35&37 FAIRFAX PLACE

Design and Access Statement Addendum
July 2021

Submitted proposals April 2021

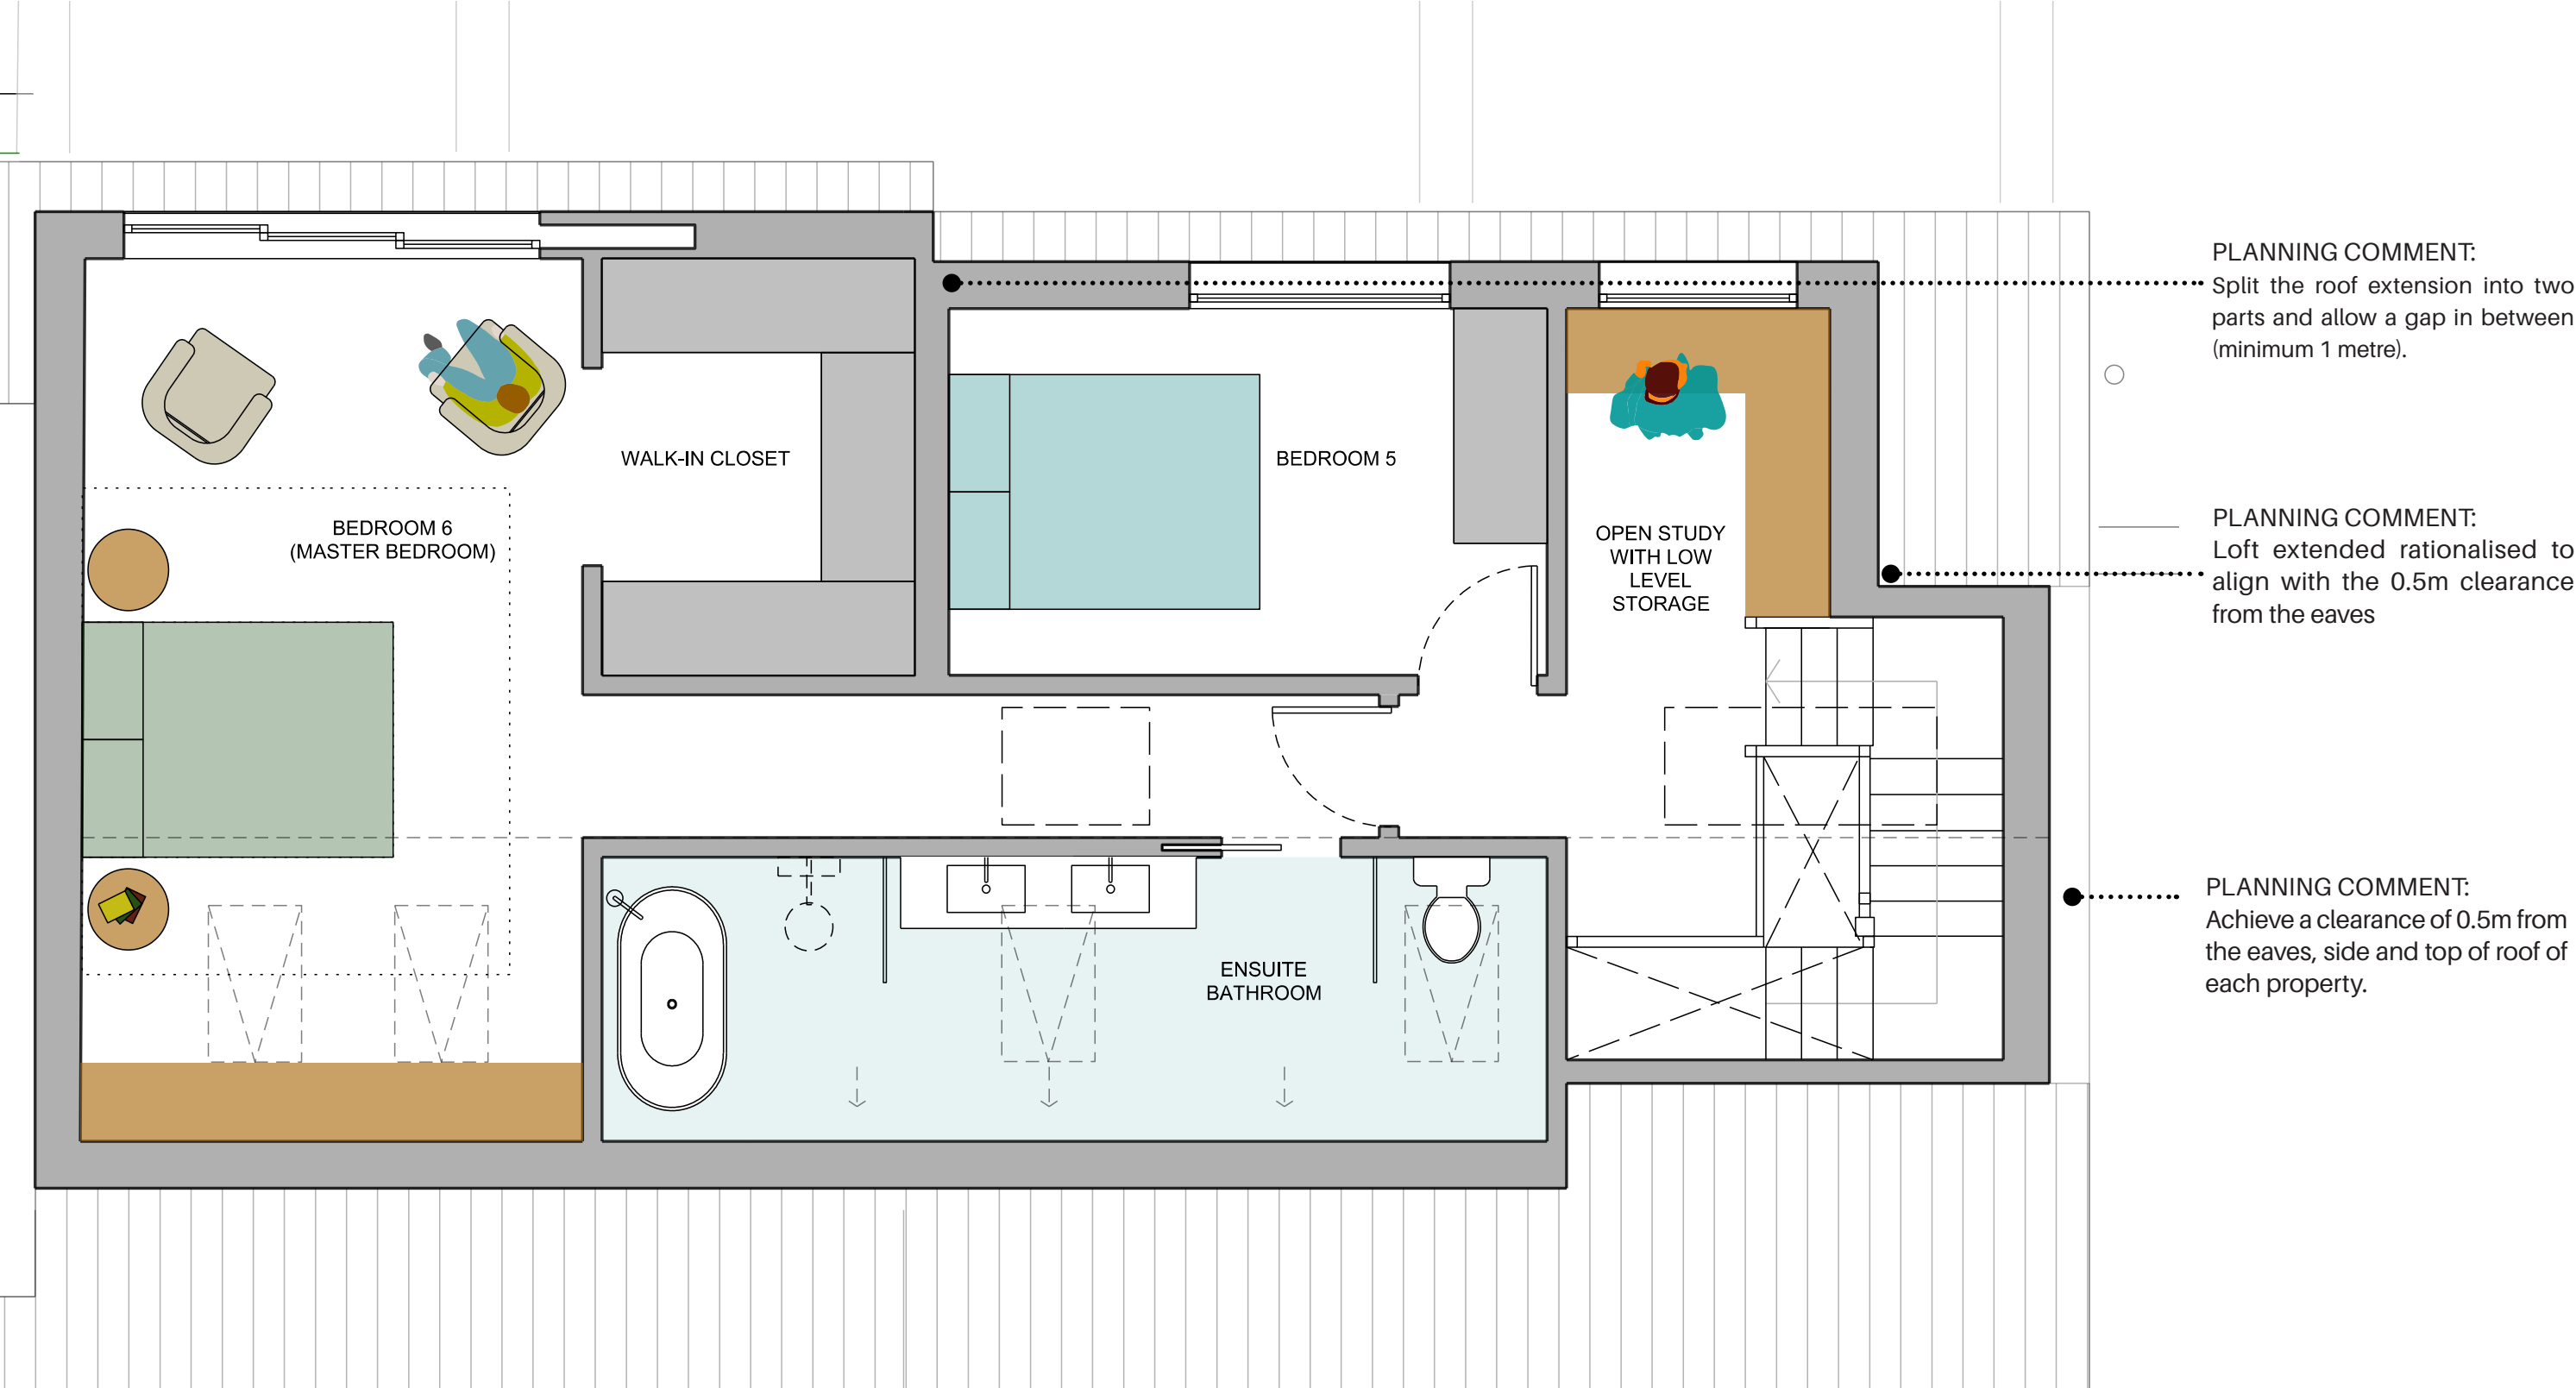
PLANNING COMMENT:
Rationalise the roof extension into simple shapes with straight lines and no doglegs

PLANNING COMMENT:
Revise the openings to the roof - the character and style of the property would suggest a less horizontal design as an appropriate amendment for the openings, responding to the existing building lines and the scale of openings on the elevation

PLANNING COMMENT:
Split the roof extension into two parts and allow a gap in between (minimum 1 metre).

PLANNING COMMENT:
Achieve a clearance of 0.5m from the eaves, side and top of roof of each property.

PLANNING COMMENT:
Railings should be black painted cast iron or similar painted metal as this would integrate more successfully with the property than glazed balustrades.

AMENDMENT:
Proposed dormers rationalised to provide the 0.5m clearance from the eaves

AMENDMENT:
Revised openings to the roof, responding to the existing building line and scale of openings to the ground and first floor elevations.

AMENDMENT:
Dormers divided into two with a 1m distance between dormer cheeks.

AMENDMENT:
0.5m offset from dormer cheek to the party wall line.

AMENDMENT:
Balcony and balustrade removed.

AMENDMENT:
Replacement of the Juliet balcony with a new window matching in size and style with the existing.

Submitted proposals April 2021: Roof plan

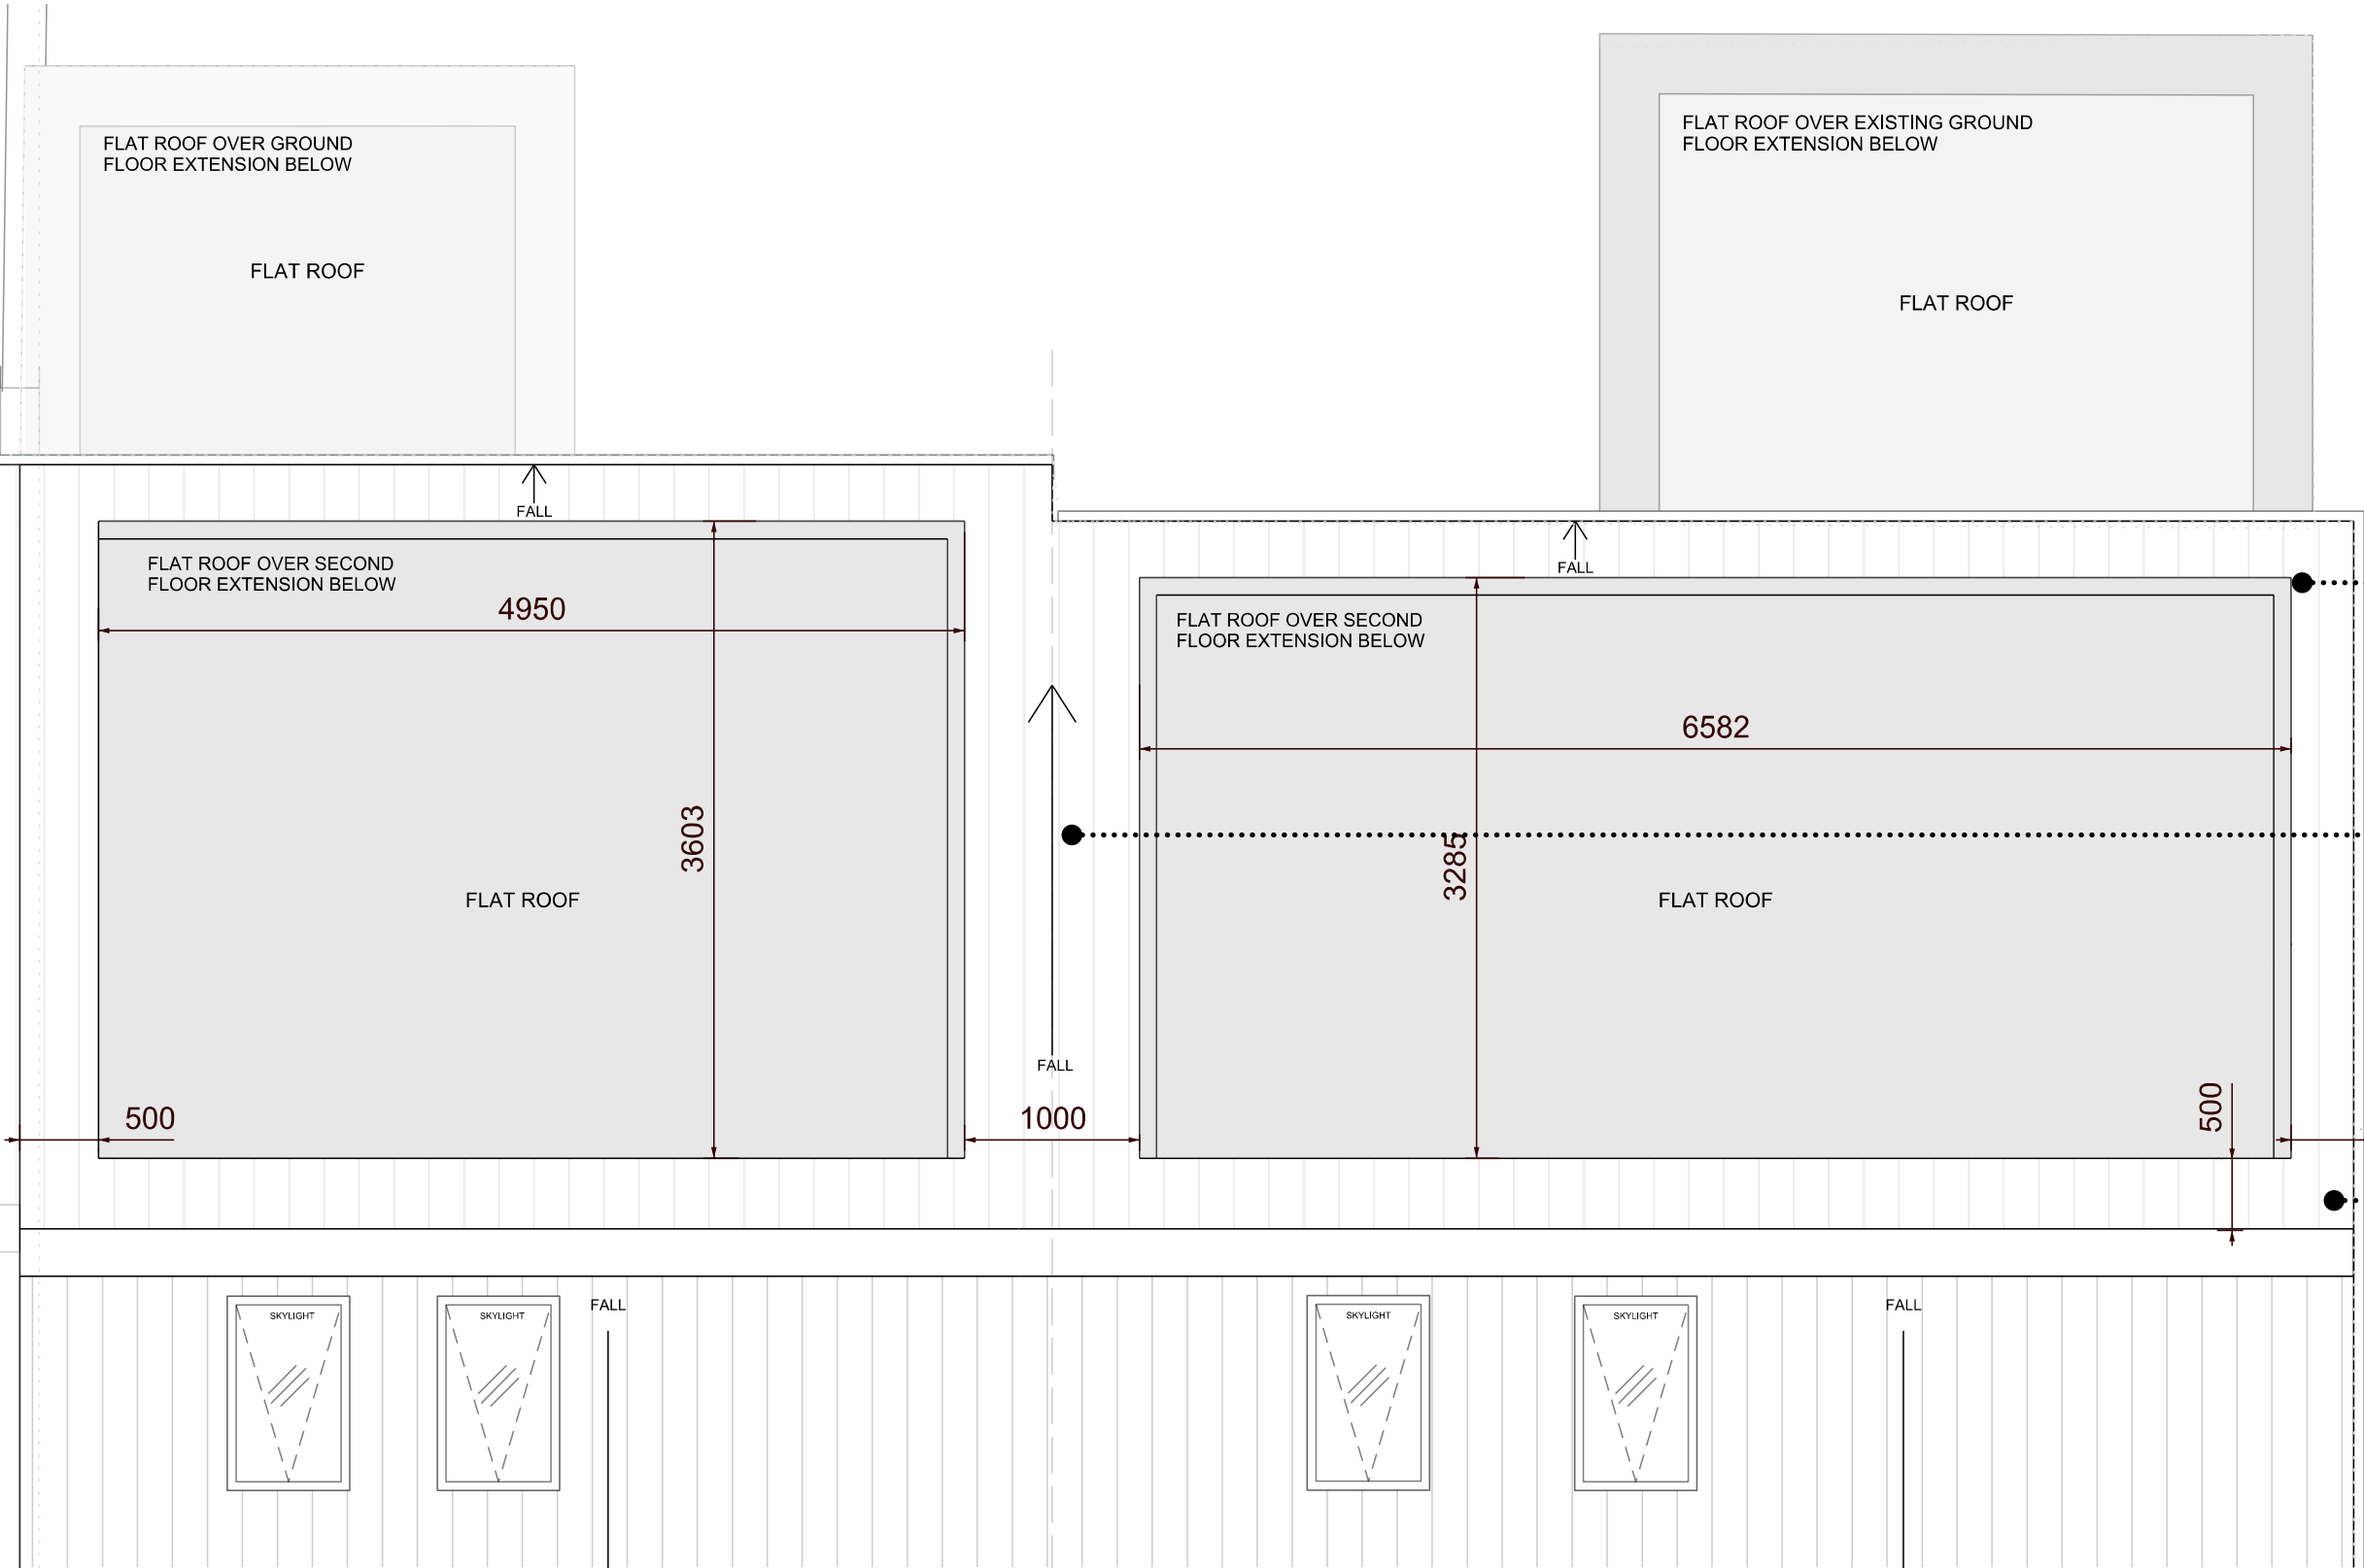
PLANNING COMMENT:
Loft extended rationalised to align with the 0.5m clearance from the eaves

PLANNING COMMENT:
Split the roof extension into two parts and allow a gap in between (minimum 1 metre).

PLANNING COMMENT:
Achieve a clearance of 0.5m from the eaves, side and top of roof of each property.

AMENDMENT:
Proposed dormers rationalised to provide the 0.5m clearance from the eaves.

AMENDMENT:
Dormers divided into two with a 1m distance between dormer cheeks.

AMENDMENT:
0.5m offset from dormer cheek to the party wall line.
